Mark Sweater Ltd.

1st March 2015

Structural Inspection Report

Observations & Actions

**Building 1:
Locally heavy floor loading in some storage
areas**

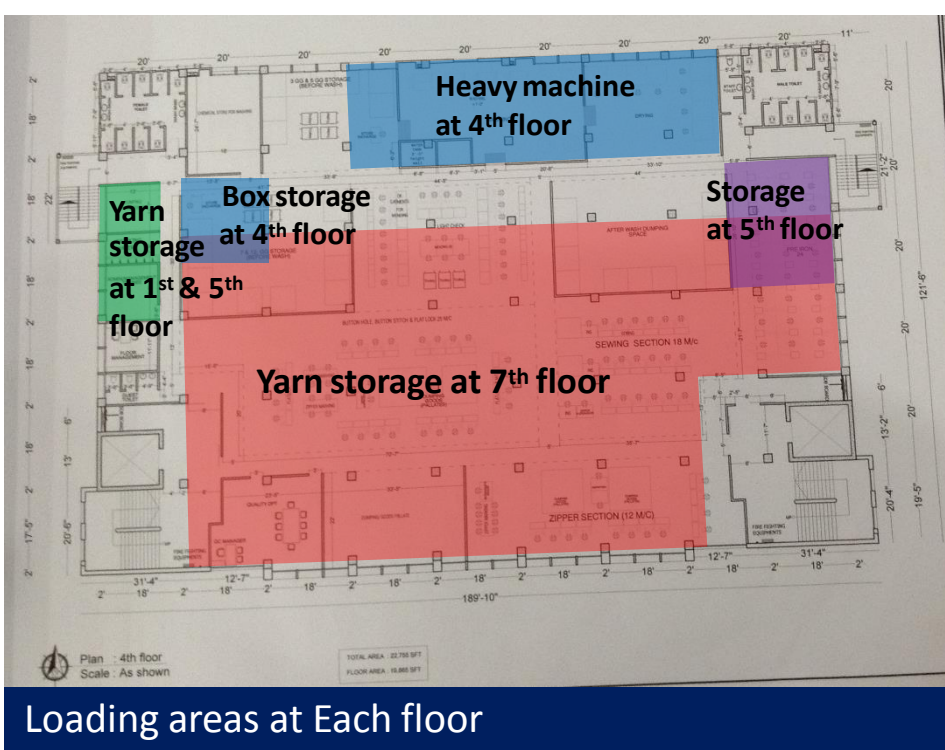
Loading areas at Each floor

1st Floor – Yarn storage

4th Floor – Box storage

4th Floor – Heavily loaded machine

7th Floor – Yarn storage

Locally heavy floor loading in some storage areas

- Factory Engineer to investigate if the applied loading can be safely carried by the slabs, beams and by the columns.
- Produce and actively manage a loading plan for all floor plates within the factory giving consideration to floor capacity and column capacity.
